# Appendix I Community Involvement and Agency Coordination after Draft EIS Publication

## Agency Comments and Project Team Responses

**Re: Tier 1 Draft Environmental Impact Statement for the South Bridge Connector Project, Brown County, Wisconsin, CEQ No. 20200128**

Sheet 4 of 11

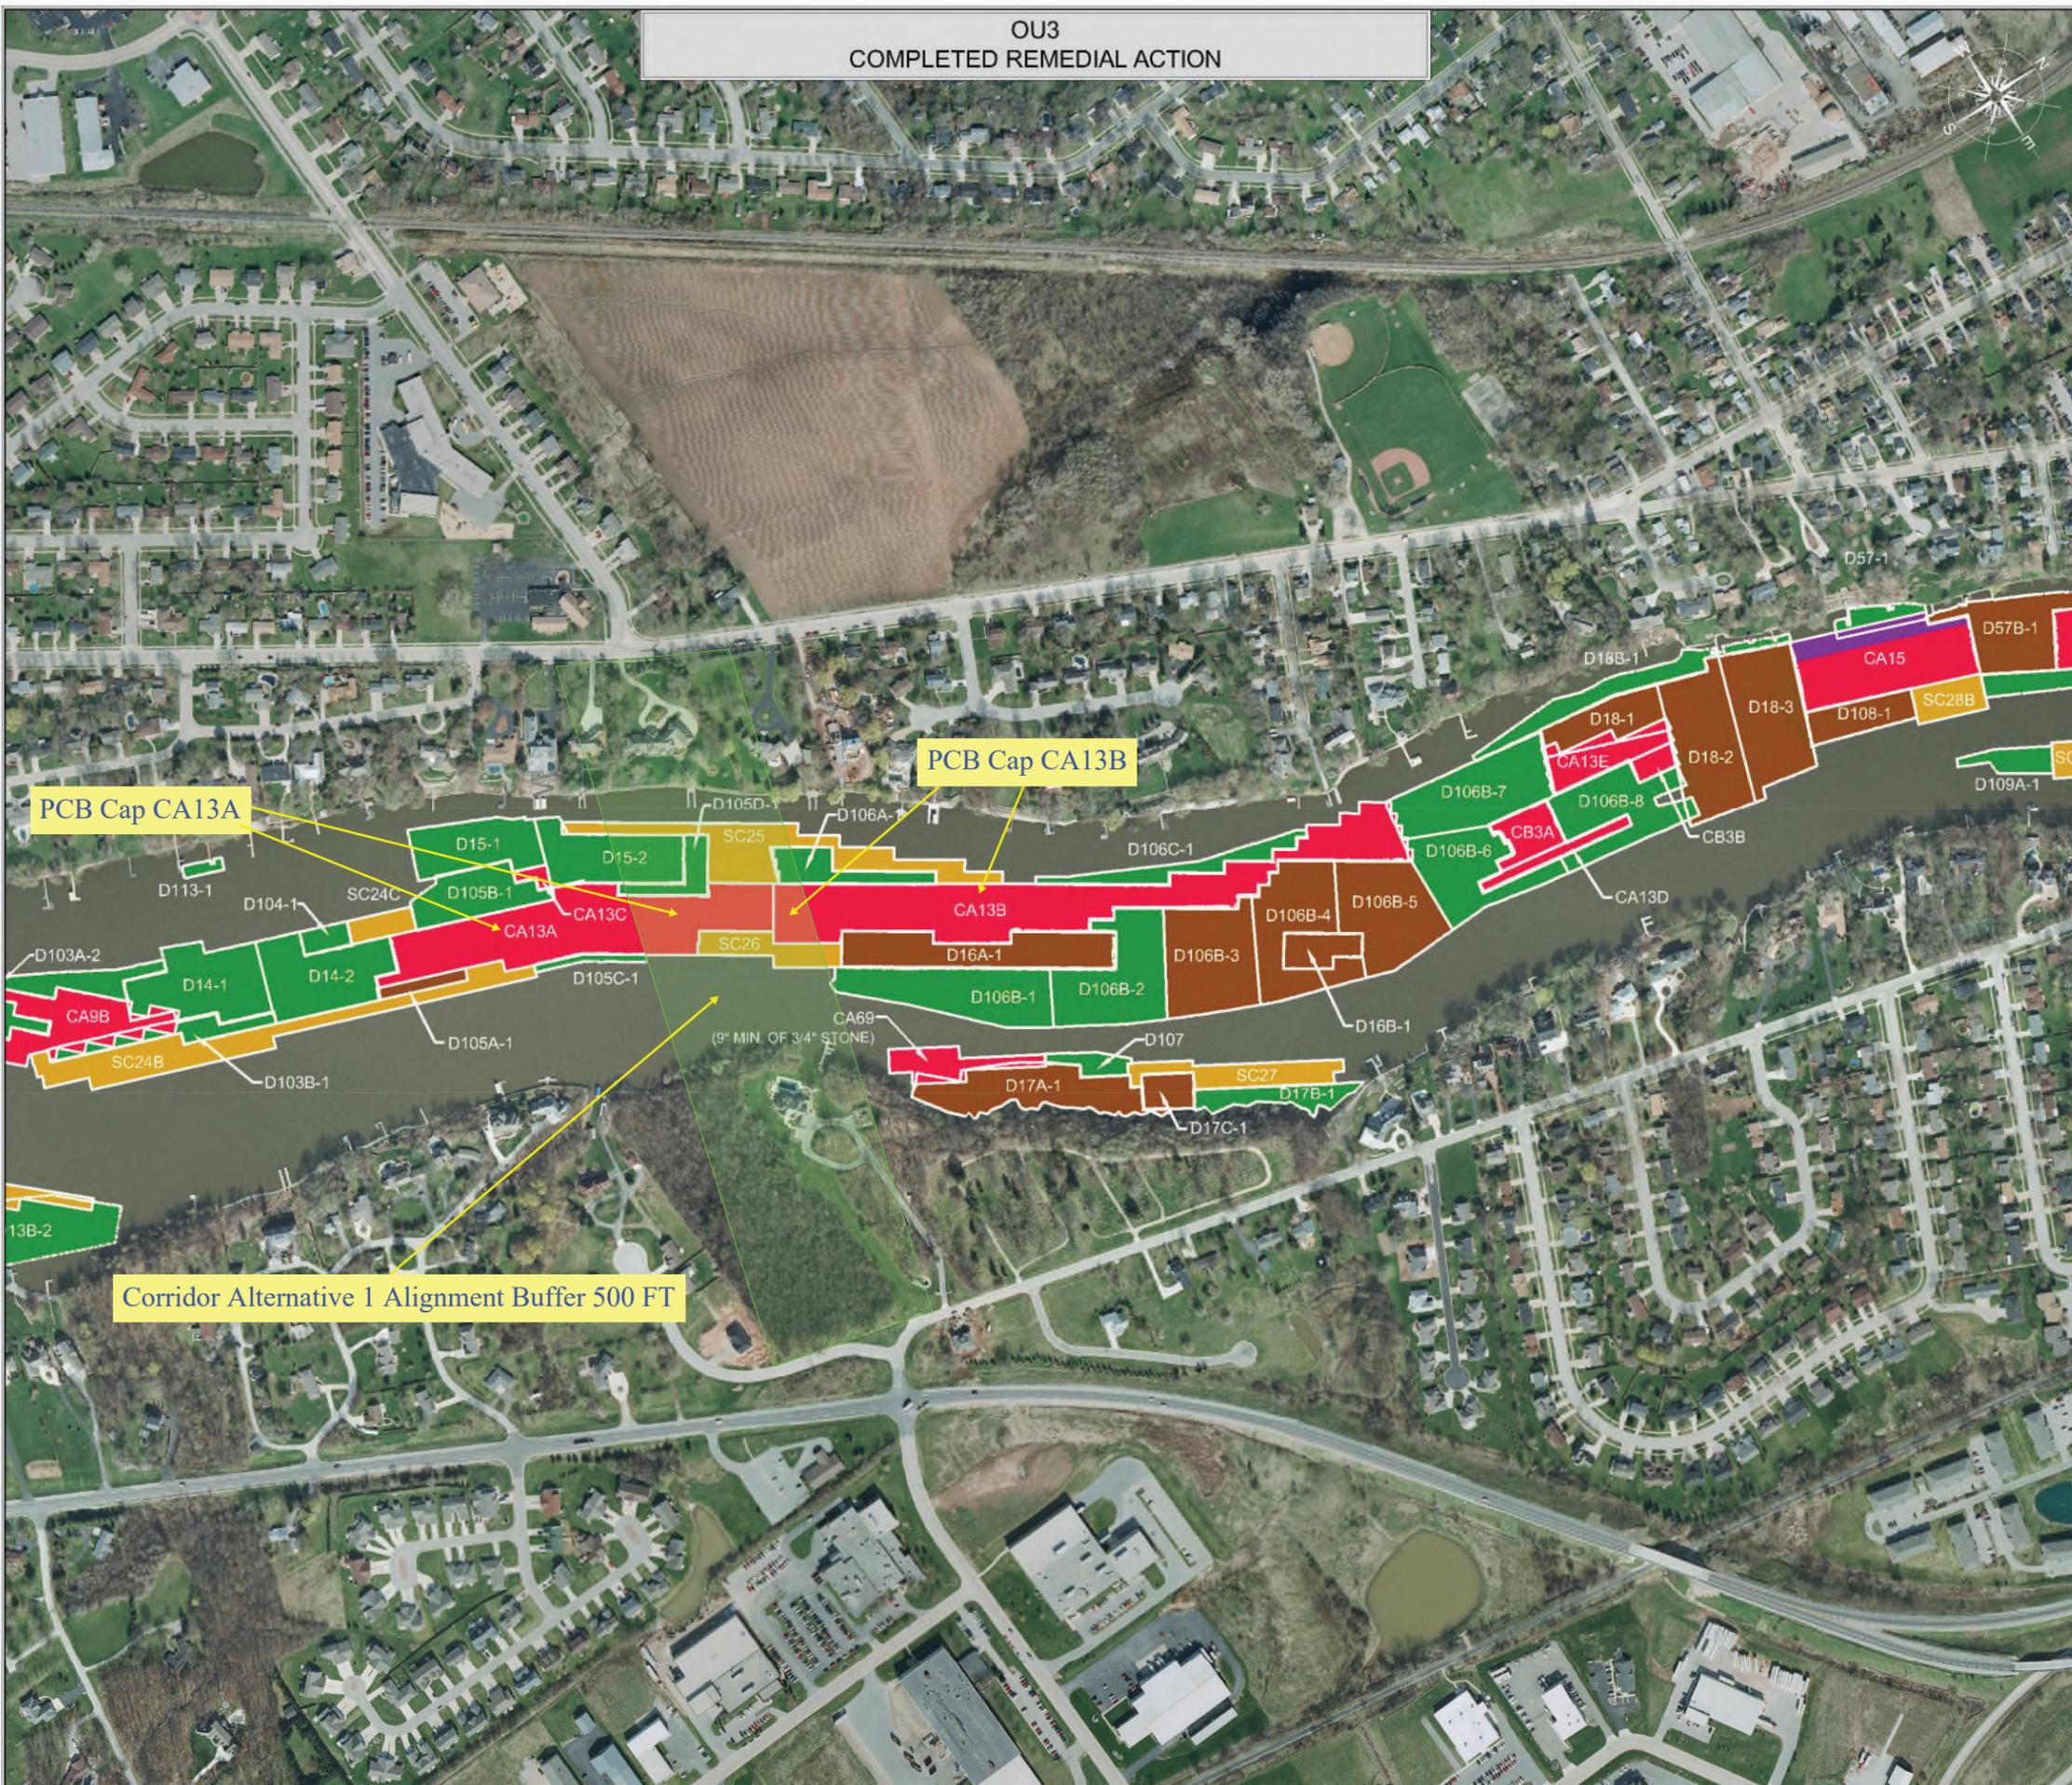
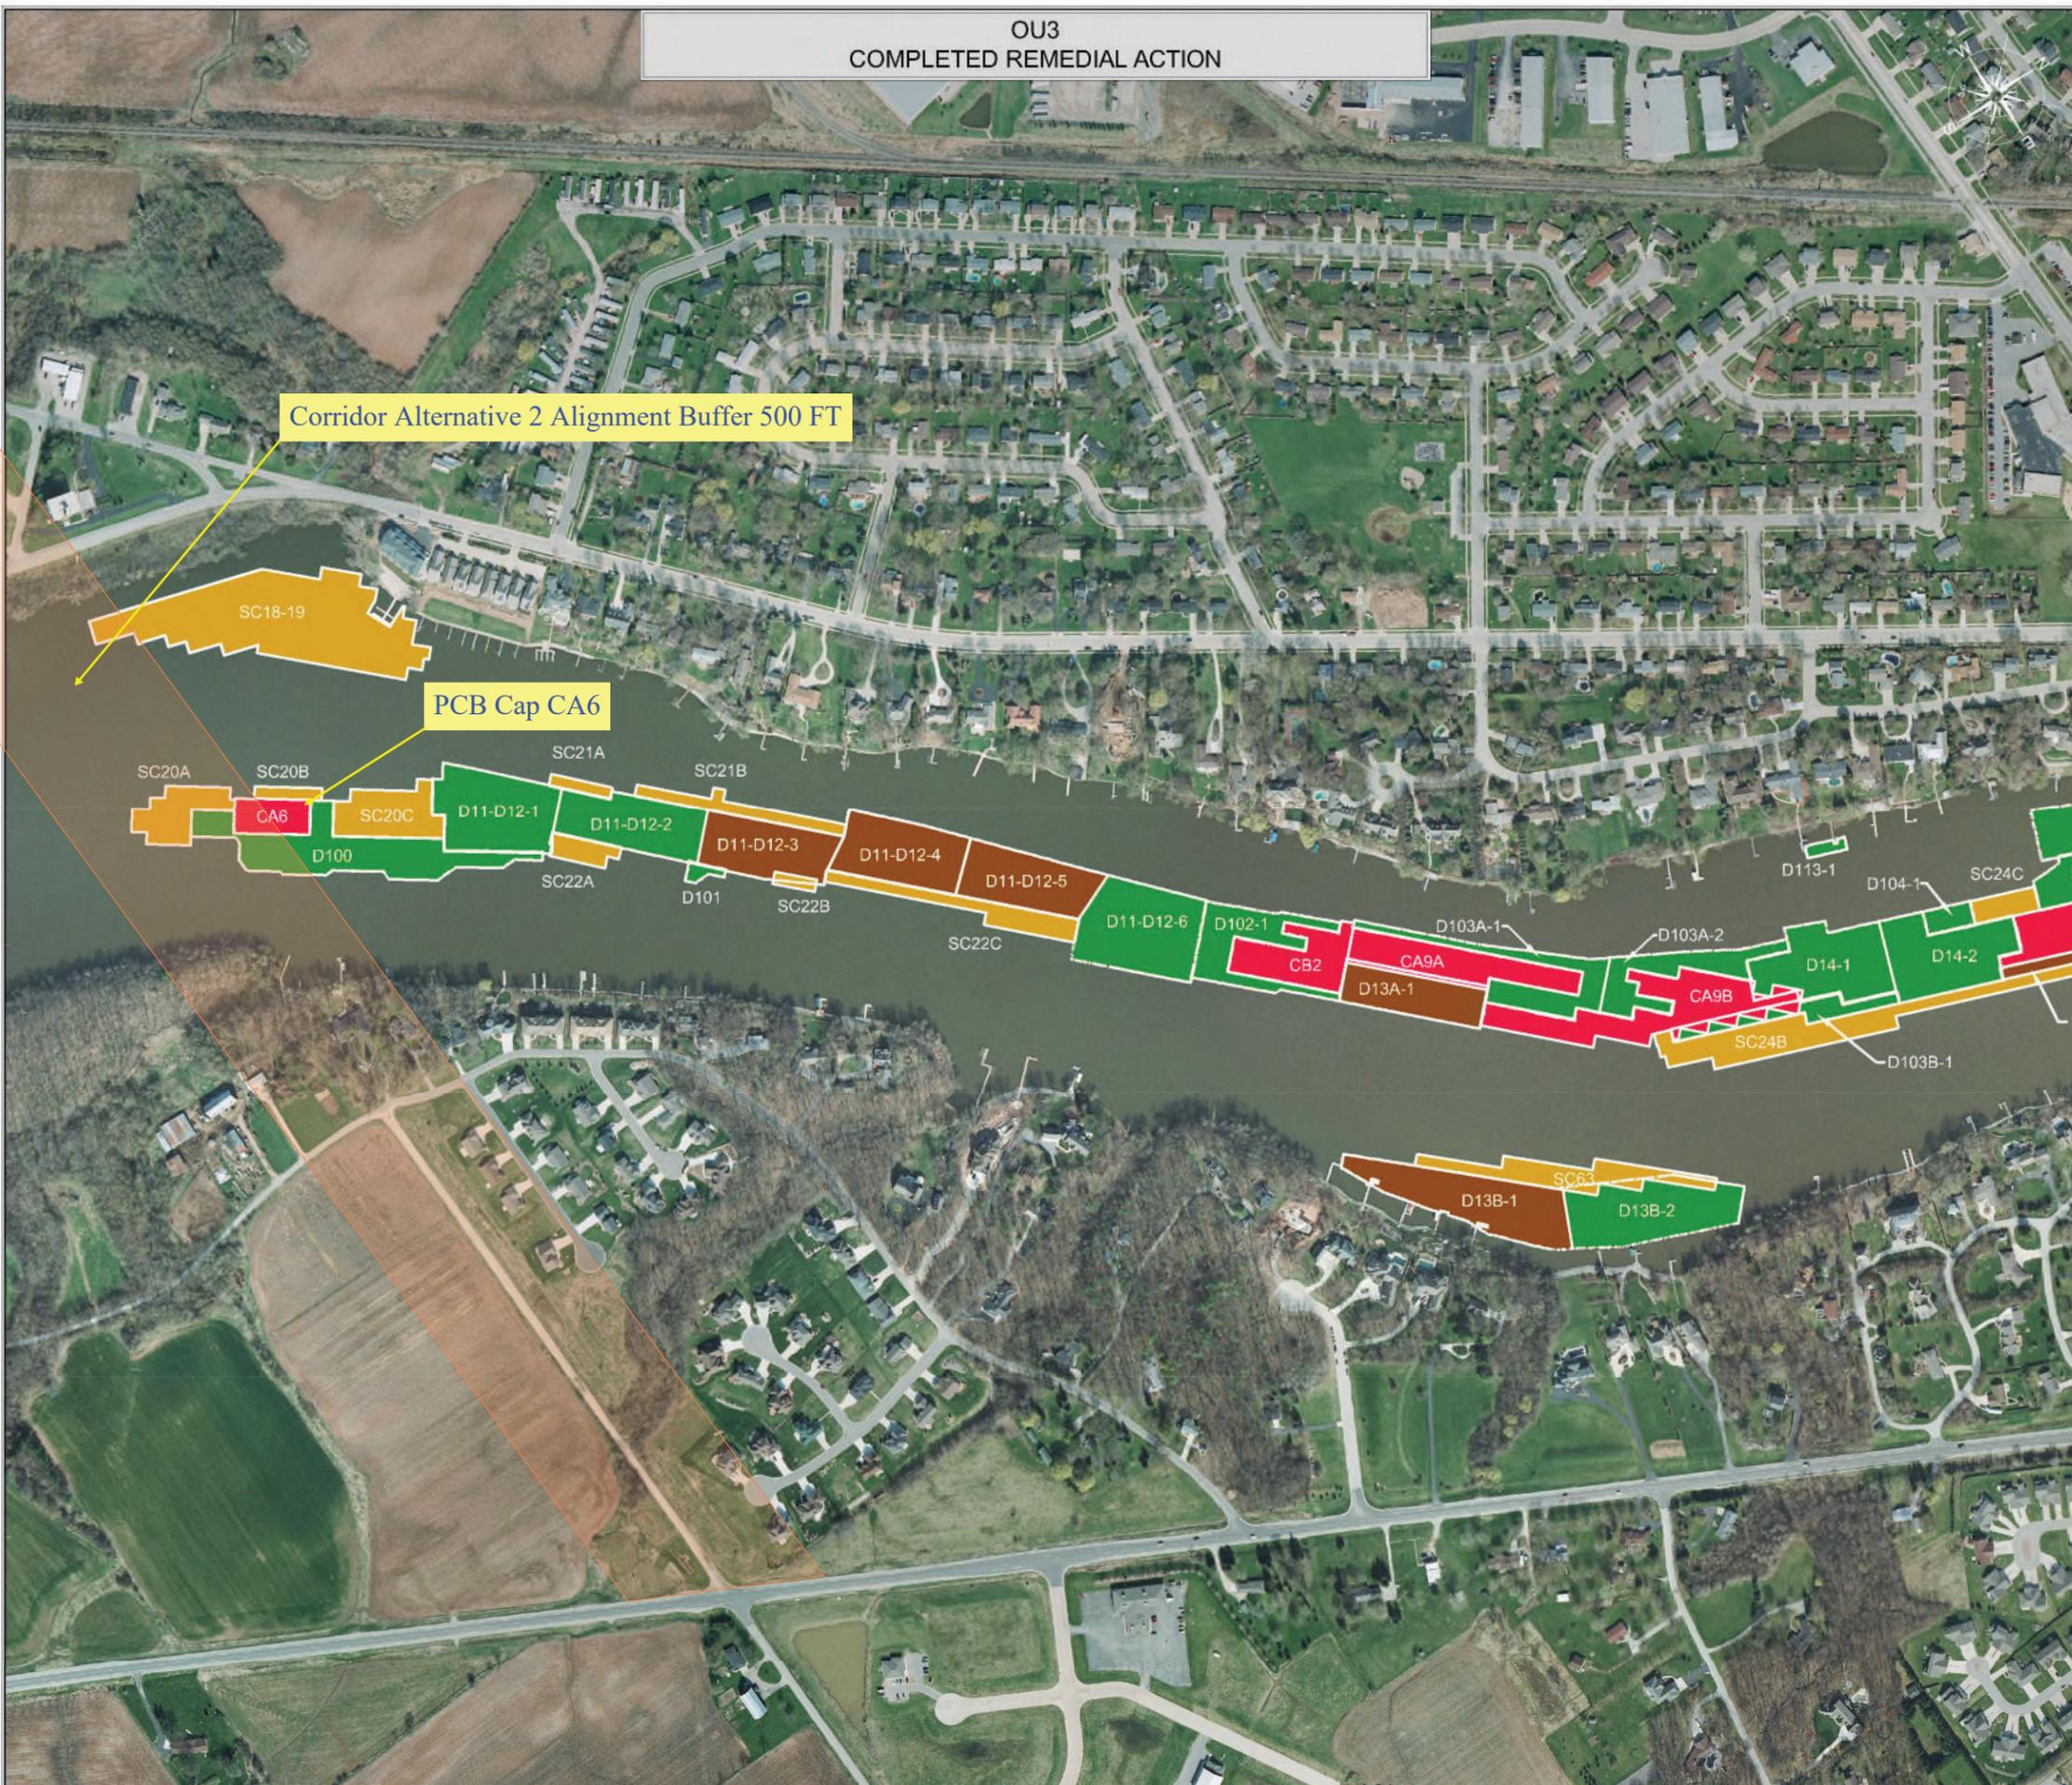
8.	There should be some discussion of wildlife and fisheries impacts as well and impacts to the Fox River and the Lower Fox River PCB cleanup efforts (e.g., engineered cap impacts). See attached file (Location of Corridors and PCB Caps in LFR.pdf). There is also a 24-inch water intake siphon line structure near Alternative Corridor 2 to be considered. See attached file (Siphon Intake Line for Alternative Corridor 2.pdf).	Information was added on impacts to wildlife and fisheries.  Information was also added, concluding that Corridor Alternative 2 would have less impact on the Lower Fox River cleanup efforts because it crosses fewer capped areas containing contaminated sediment than Corridor Alternative 1.  Information on the Siphon added to Section 3.9, Water Resources. Impacts to the siphon are not anticipated
